TOWNSVILLE
PORT EXPANSION
PROJECT

SECTION 16

Transport and Infrastructure

16.2 Response to Submissions

Figure 16.1 Draft Potential Haulage Routes

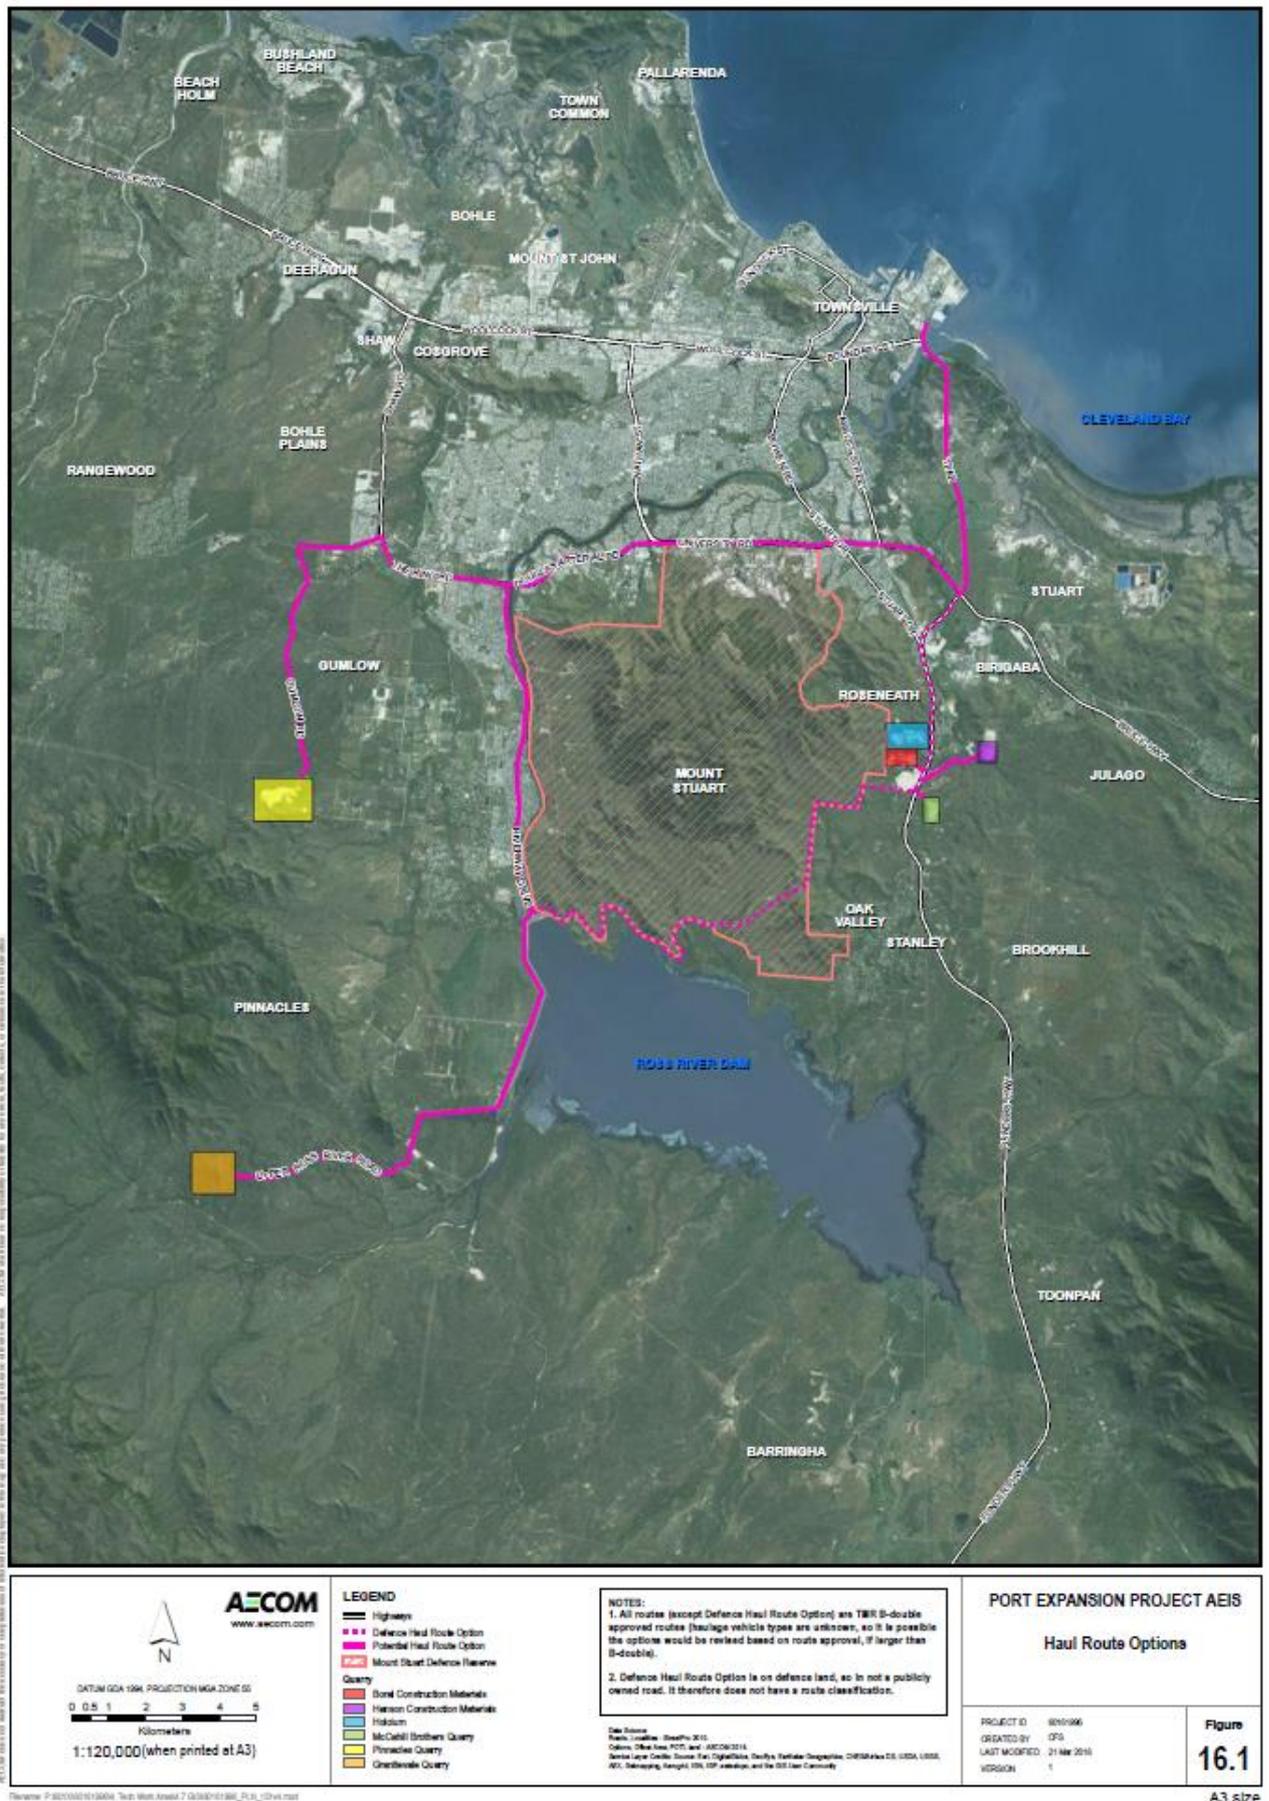
Two submissions raised the impact of construction haulage activities on the existing transport networks. It was requested that quarry locations and the proposed haulage routes to the Port are identified and assessed.

An indicative haulage plan is provided as [Figure 16.1](#) to illustrate the preferred quarry locations and potential haulage routes relative to the Port. It is expected that approximately 50% of the quarry material will be sourced from the Granitevale Quarry and the remaining material will be sourced from other local quarries and hauled via the Flinders Highway. It is envisaged that regardless of the quarry/s selected that the Townsville Port Access Road will be the preferred access route into the Port to minimise impacts to the community. A Road Impact Assessment, including a Pavement Impact Assessment and Traffic Operations Assessment, is proposed to be undertaken during detailed design, and provided a minimum of six months prior to haulage of quarry material commencing, to assess potential impacts to the State Controlled Road Network based on staging requirements and final haulage route.

Figure 16.2 Comparison of traffic volumes from EIS to the revised design AEIS

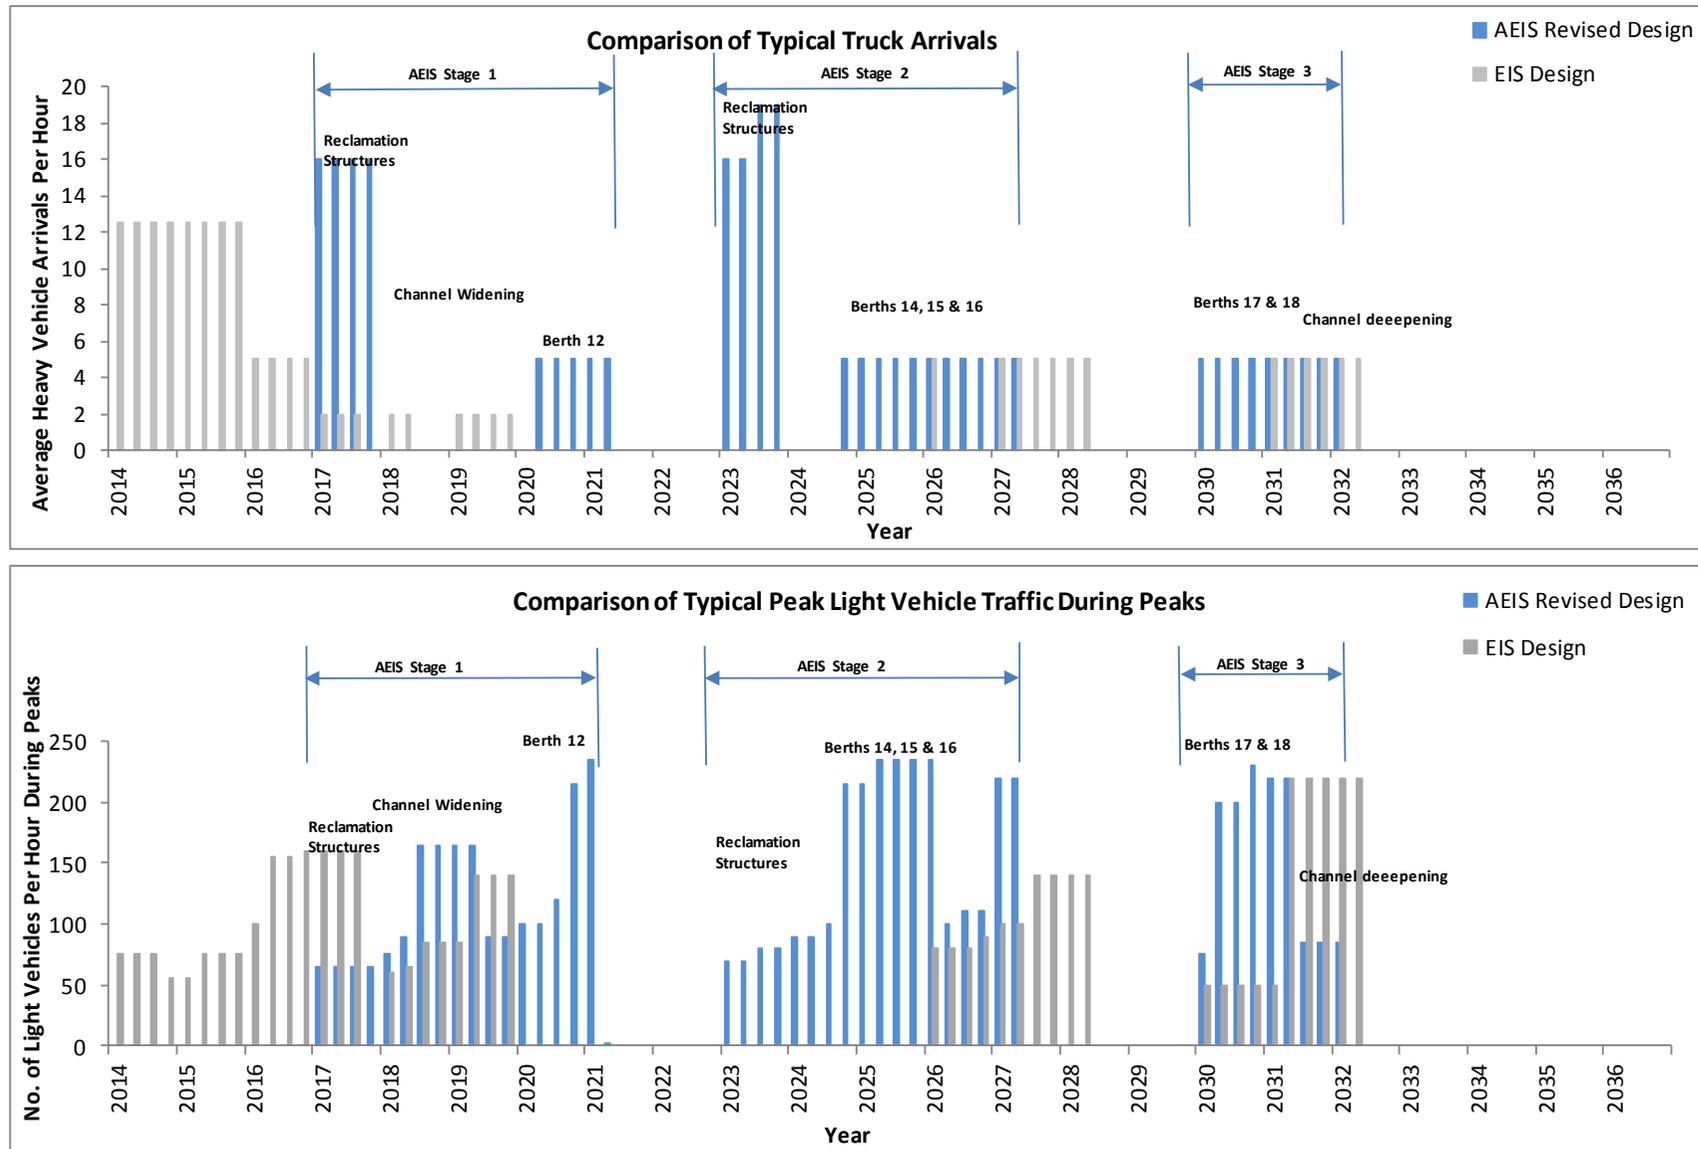
DTMR and TCC raised queries regarding the adequacy of the Traffic Operations Assessment undertaken as part of the EIS, with a request for a short and long term Traffic Master Plan. [Section B.14.4](#) of the EIS provides an assessment of transport related impacts relevant to the PEP, based on construction and operational assumptions outlined in [Appendix Q.1](#) and [Q.2](#) of the EIS. This assessment is based on baseline data, with applicable growth rates and other contributing factors applied. This was considered the most appropriate method of assessment based on the scope and scale of the PEP. Further, changes to the transport network, since the time of carrying out the baseline studies, and as highlighted in the submissions, illustrate how quickly Traffic Operations Assessments become outdated. This supports the case for assessment closer to the time of construction.

Changes to traffic volumes, due to the refined design, have been assessed through a series of semi-quantitative comparisons of heavy and light vehicle traffic movements. This information is based on the revised staging and extrapolation of original traffic assumptions and is summarised in the [Figure 16.2](#). This figure illustrates potential vehicle movements during each construction stage.

Light vehicle peaks have also changed since the EIS as illustrated in [Figure 16.2](#). Typically highest peaks for light vehicles occur during berth construction, whilst heavy vehicle traffic movements are higher during bulk material haulage periods of the Project.
